**In the Matter of** an application for approvals by  
Matakanui Gold Limited to establish,  
operate, rehabilitate and ultimately  
close an open pit and underground  
gold mining operation known as the  
Bendigo-Ophir Gold Project

**Statement of Evidence of  
Andrew Alan Metherell on behalf of  
Matakanui Gold Limited in response to  
Section 53 Feedback  
Traffic**

**Figure 1: SH8A Red Bridge**

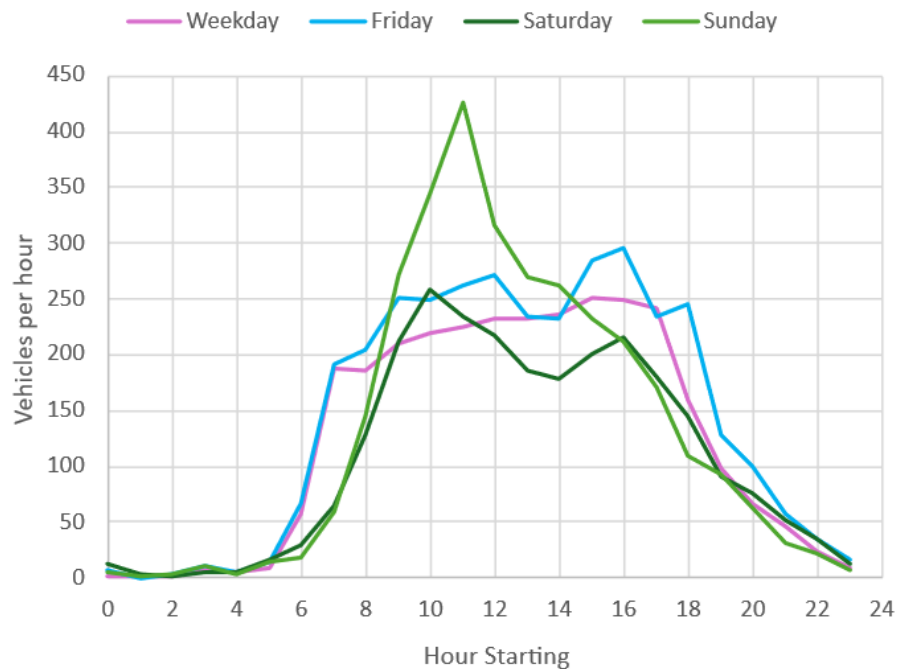
10. Mr Martineau for Sustainable Tarras (paragraph 10) considers the arrival and departure patterns of staff will put additional pressure on existing network “pinch points” which are “already under strain”, with the single lane traffic signal controlled “Red Bridge” on SH8A crossing the Clutha River Mata Au specifically mentioned. I consider the Integrated Transport Assessment (ITA) suitably addresses wider area effects with a comparison of traffic volumes generated by the site and traffic volumes using the state highway network, which has a function of accommodating through traffic. However, to address the comments made, I have carried out further assessment of the Red Bridge.

11. The traffic signals were installed in 2024. The bridge shown in **Figure 1** is some 25km from the SH8 / Ardgour Road intersection on a different part of the state highway network, and was not specifically assessed in the ITA.

16. Whilst it is difficult to fully model a single lane bridge operation, I have carried out a SIDRA Intersection modelling analysis to assess the indicative capacity and performance, utilising an all red time in each direction of 25 seconds. To be conservative, I adopted the Friday 4-5 pm period to ensure peak traffic volumes are

17. The analysis indicates average stop line vehicle delay of approximately 38 seconds per vehicle at existing traffic volumes, and operating at a degree of saturation (representing volume to capacity) of 0.49. This delay mostly relates to the long red time, rather than being associated with high traffic demand. I have then doubled traffic volumes, indicative of 20 years of growth of SH8A traffic at 5% per annum from 2024 volumes (an extra 300 vph). The bridge operation has average stop line delay of 45 seconds per vehicle and degree of saturation (representing volume to capacity) of 0.66 in the long term. Clearly the bridge has capacity to accommodate long term growth in its existing form, with proposal related contributions to that growth being comparably small.

18. In my opinion, the low generated traffic on the BOGP site will not materially affect operation of the SH8A Red Bridge, nor NZTA decision making or timing for further future upgrades.
